INSTRUCTION TO SERVICE

ITS61407		DATE:07/23/2025
SECTION:	526 - SEATS, STANCHIONS, MODESTY PANELS	
SUBJECT:	Rework emergency exit window decals – J45 EN 56P	
ISSUE:	Emergency exits labelling are noncompliant to the requirements of FMVSS Standard No. 217; Bus emergency exits and window retention and release.	
SUMMARY:	Addition of corrected/additional decals to bring the coaches back into compliance. Ensure instructional labelling are within the occupant space required by the standard.

Ref. NHTSA Recall No.	Ref. Transport Canada Recall No.
24V457	2025-367

Figure 1: RH Curbside Interior of the Coach

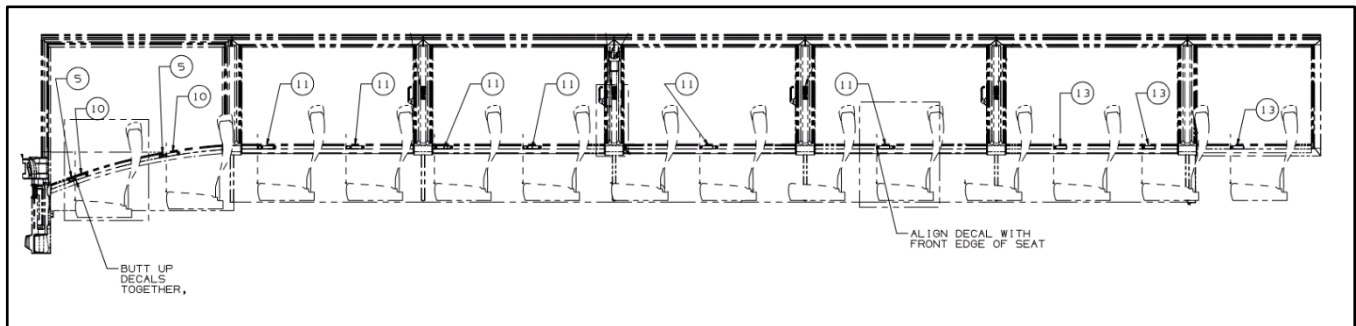
3. On the interior of the coach, locate the new horizontal emergency nameplates. Install ref (PN: 1133853).
4. It is important to follow nameplates positioning as shown on Figure 1 and 2 for coach to be safety compliant.

Note: If the decals exist in the below locations, confirm whether the PNs match. If decals don't match, remove by drilling the rivet and install new decals as per below.

Figure 3: Nameplate and Existing Decal

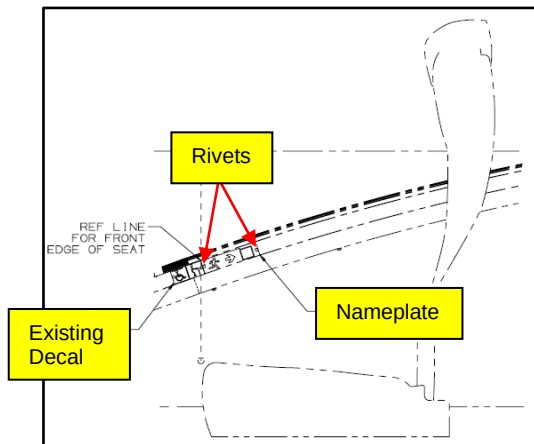
5. As shown on Figure 3, butt up nameplate together with existing decal (NF PN: 03-15-7278 ref). If coach has existing decal (NF PN: 03-15-7278) at last few passenger rows, butt up name plate together (See Figure 5).
6. Position nameplates, items 10 to 13, as close as possible to the front edge of the seat cushion (See Figure 4).
7. As required, match-drill a 0.12" dia x 0.37" deep hole using the nameplate being mounted as a template. Repair/patch up existing unused holes as necessary.
8. Use rivets (NF PN: 19-13-24) to mount new nameplates at the specified locations.
